Item 3.**Development Application: 58-78 and 82-106 Oxford Street, Darlinghurst - D/2020/1071**

File No.: D/2020/1071

Summary

Figure 7: Reduction in skylight glazing to Group 1 (outlined in red)

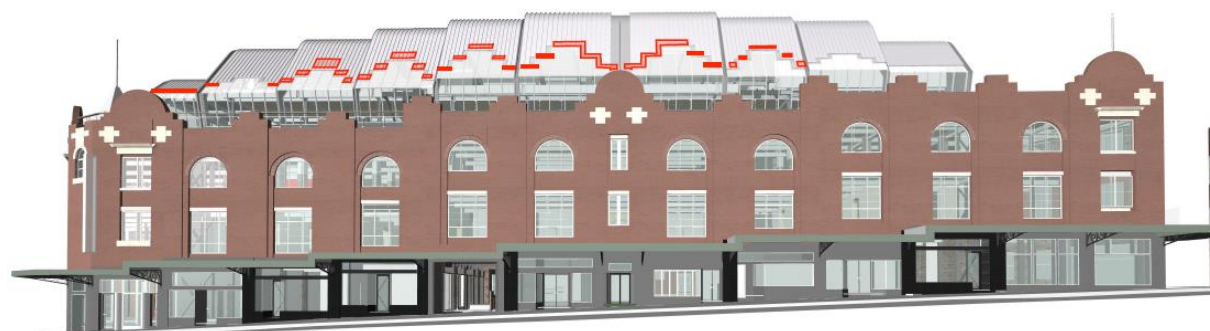
Local Planning Panel Recommendations	Design response
Environmental Performance	<p>The extent of glazing and detailing of the glazing is refined to enhance the environmental performance of the building.</p> <p>The amendments include:</p> <ul style="list-style-type: none"> • Increased sun shading on the northern facade to 450mm louvres. • Reduced roof glazing, minimising the heat loads on the internal office space through reduced window openings. • The integration of metal mesh interlayer in the roof glazing to enhance the passive sun shading of the glazing, further reducing heat loads and need for air conditioning. <p>The proposal achieves a 4.5 star NABERS rating. This is consistent with the requirements of Section 3.6 of the Sydney DCP 2012, which outlines that a 5 star NABERS rating is not required where the upgrade works would negatively impact on significant heritage fabric or the heritage significance of a heritage item.</p>

Figure 12: Proposed louvres in section (indicated in red)

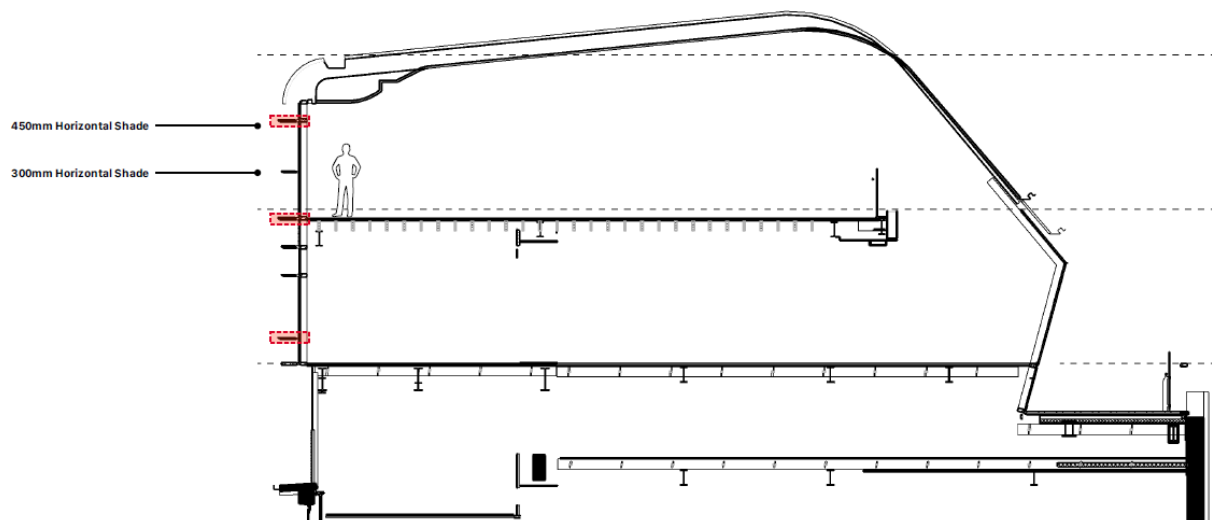
Design Advisory Panel Recommendations	Design response
Street to capitalise on the potential views to the harbour.	<p>The amendments include:</p> <ul style="list-style-type: none"> • Increased sun shading on the northern facade to 450mm louvres • Reduced roof glazing, minimising the heat loads on the internal office space through reduced window openings • The integration of metal mesh interlayer in the roof glazing to enhance the passive sun shading of the glazing, further reducing heat loads and need for mechanical conditioning <p>The proposal achieves a 4.5 star NABERS rating. This is consistent with the requirements of Section 3.6 of the Sydney DCP 2012 which outlines that a 5 star NABERS rating is not required where the upgrade works would negatively impact on significant heritage fabric or the heritage significance of a heritage item. The proposal was reviewed by Council's environmental advisor and is satisfactory.</p> <p>The louvres provide additional screening and privacy to neighbouring properties and prevent downward overlooking, while maintaining a suitable outlook from the proposed development.</p> <p>A provision of a roof terrace facing Foley Street is inconsistent with the draft DCP provisions, which allow a nil setback to the Foley Street frontage and was therefore not pursued.</p>

<p>Amenity, Privacy and Outlook</p>	<p>The proposal is amended to provide a series of louvres to the north-eastern facade, with a depth of 450mm, to provide additional screening and privacy to neighbouring properties and prevent downward overlooking, while maintaining a suitable outlook from the proposed development.</p> <p>The properties located on the opposite side of Foley Street are generally lower than the proposed addition except for the upper level of the residential flat building at 265 Palmer Street. Opaque glazing is proposed to parts of the north-eastern facade to prevent direct overlooking to the neighbouring property.</p>

Figure 15: Planning proposal height planes for Group 1 (Note: this image has not been amended since the roof forms have changed, however the height up to 24.4 metres has not changed)

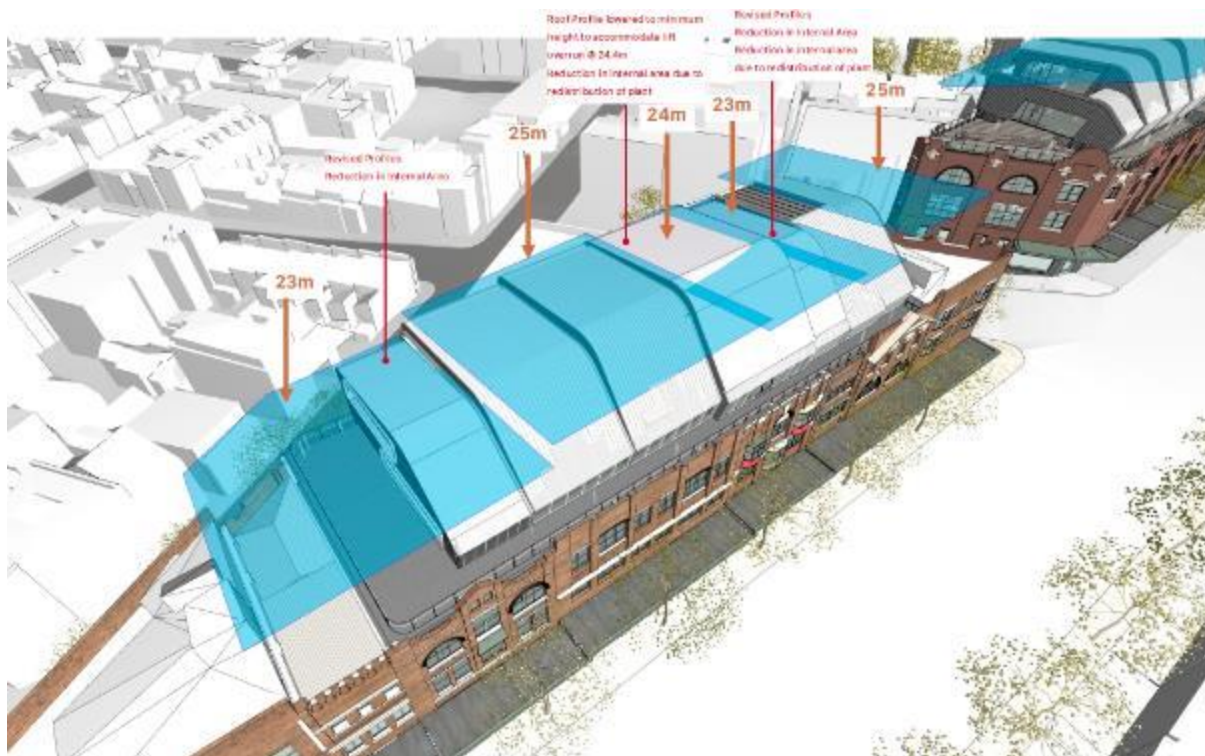
57. The proposed height of Group 1 is 24.4 metres and is consistent with the maximum height controls, except for a 400mm increase above the 24 metre height control of Group 1, which is the result of the lift overrun.

Figure 18: Sections through Group 1. The red lines indicate the current Sydney LEP 2012 height control.

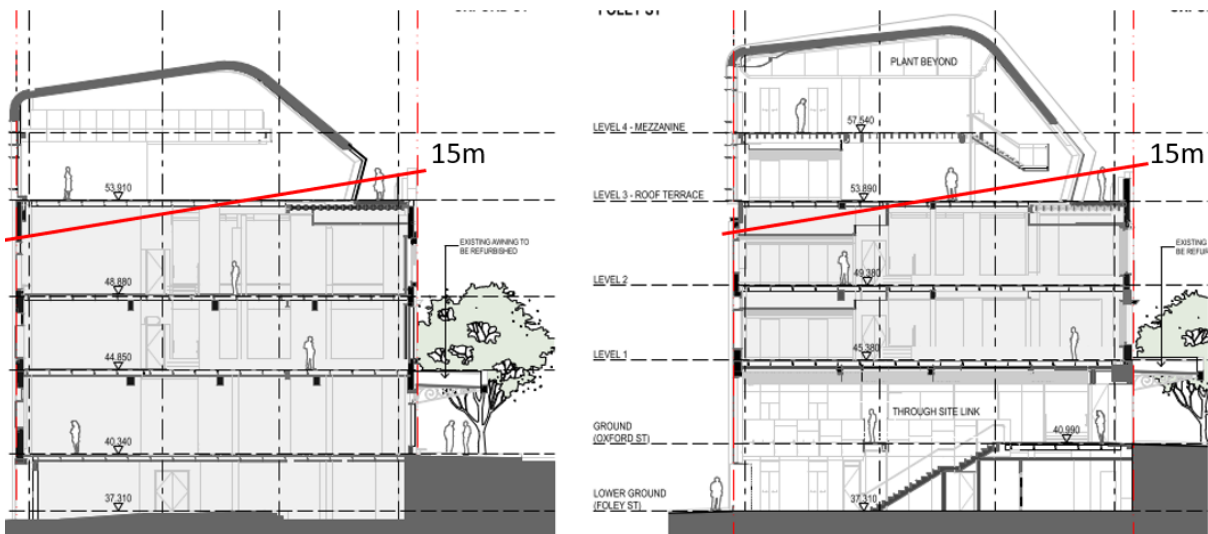
Provision	Compliance	Comment
4.3 Height of buildings	No	<p>A maximum building height of 15 metres is permitted.</p> <p>The proposed development does not comply with the maximum height of buildings development standard.</p> <p>A height of 24.4 metres is proposed for Group 1.</p> <p>A height of 24.95 metres is proposed for Group 2.</p> <p>A request to vary the height of buildings development standard in accordance with Clause 4.6 has been submitted.</p> <p>The additional height is recommended for support and this is assessed further in the 'Discussion' section below.</p>

Figure 21: Proposed setback strategy for Groups 1 and 2 (3 metre average setback indicated in red)

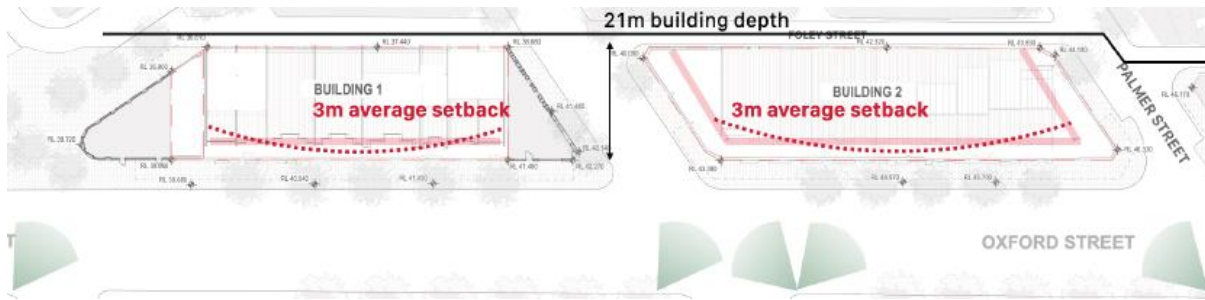
- (e) Protect solar access in neighbouring residential properties with appropriate building setbacks from all boundaries.
80. The proposal was amended to provide an increased setback to the new addition by approximately 500mm, resulting in an average 3 metre setback to both Group 1 and Group 2. The setbacks to the apex of the additions are:

82. This is assessed as being an appropriate design strategy and is consistent with the objectives of the draft DCP control and is acceptable on this basis.

Figure 31: Modelling from applicant's view loss study, as viewed from Level 6 of 302 Crown Street

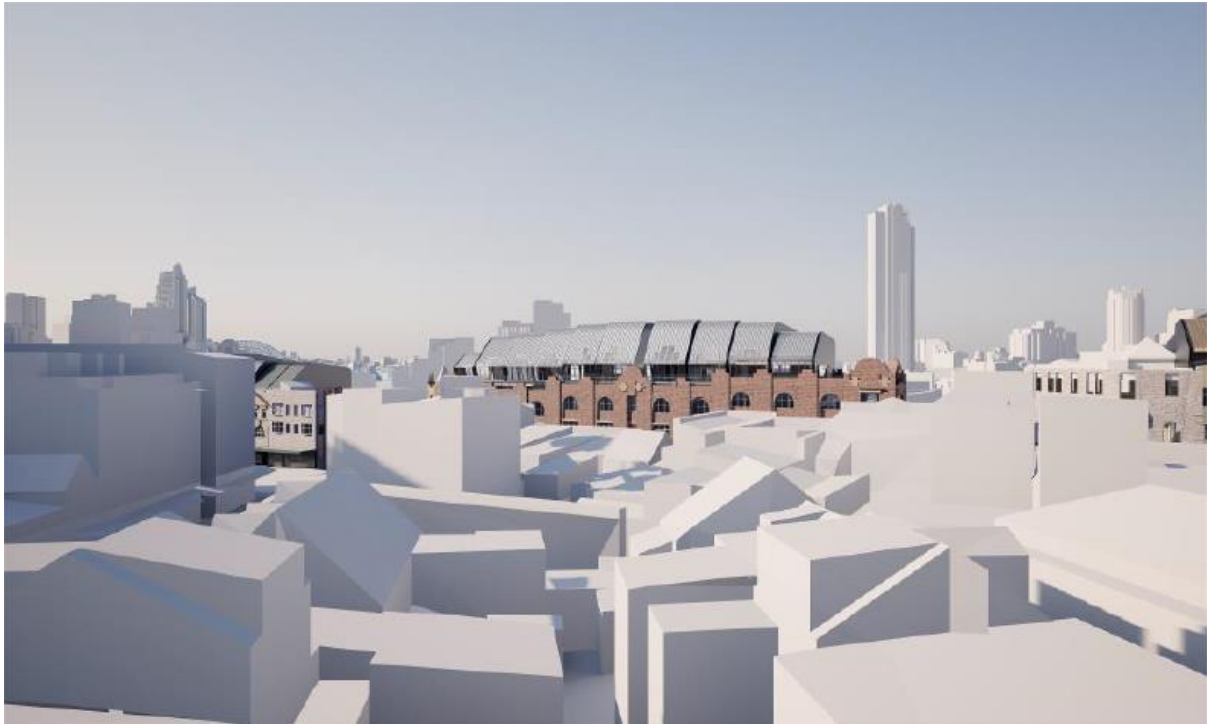
95. 302 Crown Street is located approximately 130 metres to the south of Group 2.
- (a) Views to be affected: A partial view of the Sydney Harbour Bridge and St Marys Cathedral
 - (b) Part of property viewed from: North facing apartments
 - (c) Extent of impact: The applicant's modelling has demonstrated that the views of the Sydney Harbour Bridge and the spires of St Marys Cathedral from Levels 7 and 8 will be retained. This has been verified by Council's model makers. Views from Level 6 are already obstructed, and will be further interrupted by the proposal.
 - (d) Reasonableness: The proposal would have a negligible impact on views from this property and as such, is considered reasonable.

Figure 36: Modelling from applicant's view loss study, as viewed from Level 4 of 200 Campbell Street

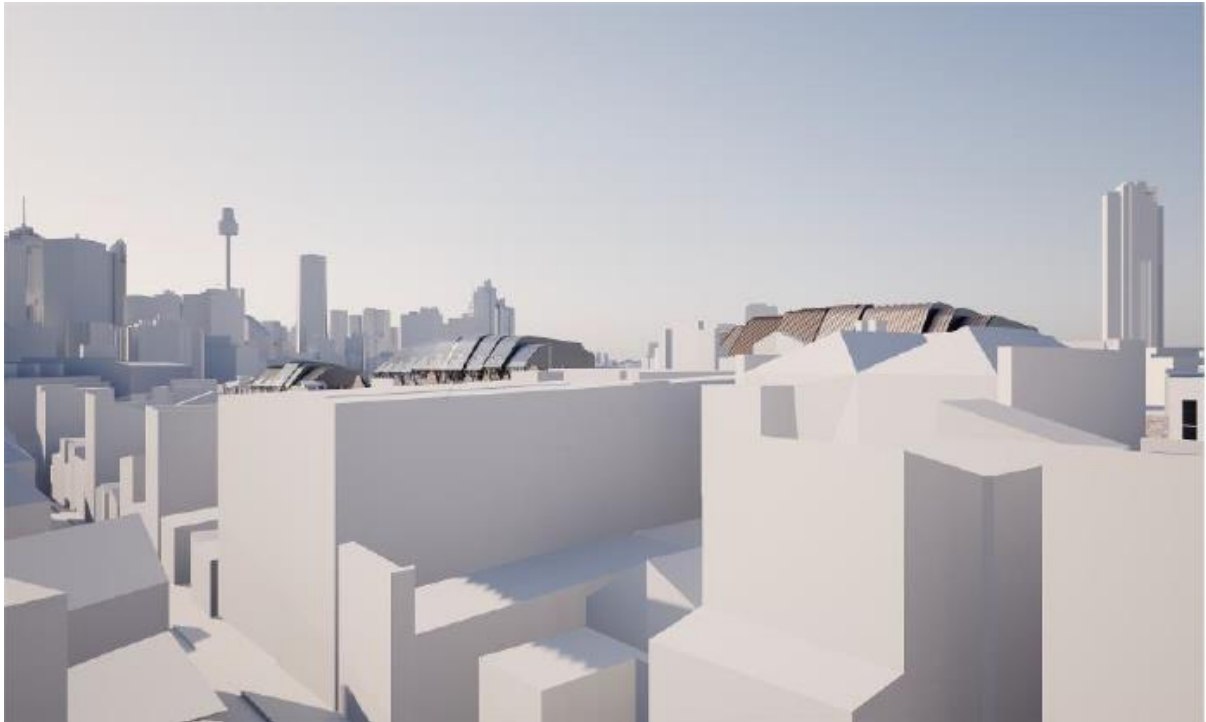
- (d) Reasonableness: The view impacts of the proposal vary depending on the level of the building. Both sides of Oxford Street benefit from an alternative height of buildings control under the planning proposal. In the above context, the view impacts of the proposal are reasonable in this instance.
